1961 Corvette: Chevrolet Product Engineering Technical Information: Spark Plug Electrode Interference With Piston

Subject: Spark Plug Electrode Interference With Piston

Model and Year: 1961 Corvette Models Equipped with Fuel Injection

Bulletin Number: Page 3-4 - Section VI - Group 2

Reworking Piston Dome - 1961 Corvette Models Equipped
With Fuel Injection

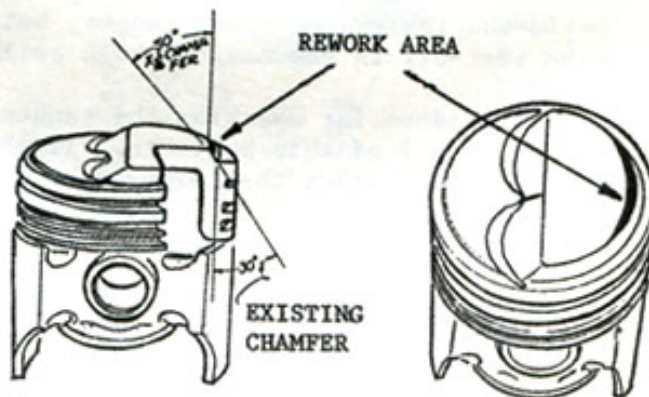
An interference condition between the spark plug ground electrode and piston dome may occur on 1961 Corvette Models equipped with fuel injection. This interference results in a bent electrode which causes insufficient spark plug gap, engine miss and subsequent poor performance.

The condition was corrected in Production effective 5-15-61 (engine date stamp F-0515) by removing 1/16" of the piston dome at the contact area as shown in the following sketch. The size of the area to be removed is approximately 1/16" thick, 1/8" wide and 1-1/2" long machined at a 50° angle. Only the top half of the dome chamfer should be removed with the lower portion remaining at the existing 30° angle.

In the event an 11:0-1 compression ratio engine equipped with fuel injection is being overhauled or if the cylinder heads are removed, each piston dome should be filed or ground off approximately 1/16" to prevent spark plug electrode interference. If only the heads are removed, the pistons should be at TDC and grease applied to the top of the pistons to insure complete remove of filings.

Whenever engine replacement is required, either partial or fitted blocks or if service pistons are being installed, the pistons should be reworked prior to installation.
